Access Compliance Report

Public Rights-of-Way

(Curb Ramps)

Intersection ID: 48313	Main Street: RIBBONWALK_TL	Cross Street: TRILLIUM_FIELDS_DR	Location: SW
ADA ID: 069AC9AE62D2	Ramp Type: Perp	Initial Pass/Fail: Fail	Overall Compliance: No
			Severity Score: 21.25

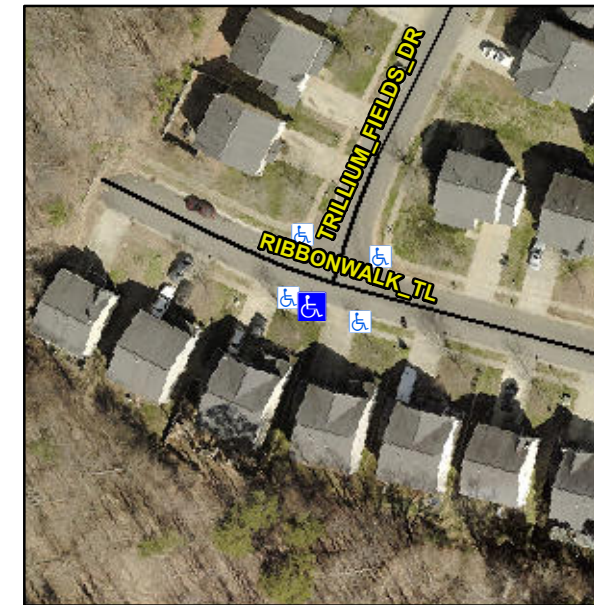
R304.5.1, R304.5.3

Compliance	Description	Data	Compliance	Description	Data
N/A	Ramp Length (in)	48.0	Yes	Ramp Slope (%)	5.7
No	Ramp Width (in)	47.5	No	Ramp XSlope (%)	5.9
N/A	Flare Type LT	N/A	N/A	Flare Type RT	N/A
N/A	Flare Slope LT (%)	N/A	N/A	Flare Slope RT (%)	N/A
N/A	Flare Traversable LT?	N/A	N/A	Flare Traversable RT?	N/A
N/A	Landing Length (in)	N/A	N/A	DWS Provided?	N/A
N/A	Landing Width (in)	N/A	N/A	DWS Contrast?	N/A
N/A	Landing Slope (%)	N/A	N/A	DWS Length (in)	N/A
N/A	Landing X Slope (%)	N/A	N/A	DWS Full Width?	N/A
N/A	Landing Curb? (Y/N)	N/A	N/A	DWS Offset (in)	N/A
N/A	Shared Landing?	N/A			
N/A	Gutter Ponding?	N/A	N/A	Gutter Slope (%)	N/A
N/A	Gutter Lip Ht (in)	0.5	N/A	Gutter X Slope (%)	N/A
N/A	Painted X Walk1?	No	N/A	Painted X Walk2?	N/A
	X Walk 1 Direction	To NE		X Walk 2 Direction	N/A
N/A	X Walk 1 Width (in)	N/A	N/A	X Walk 2 Width (in)	N/A
	X Walk 1 Slope (%)	1.7		X Walk 2 Slope (%)	N/A
	X Walk 1 X Slope (%)	5.9		X Walk 2 X Slope (%)	N/A

Remove & Replace Entire Ramp.
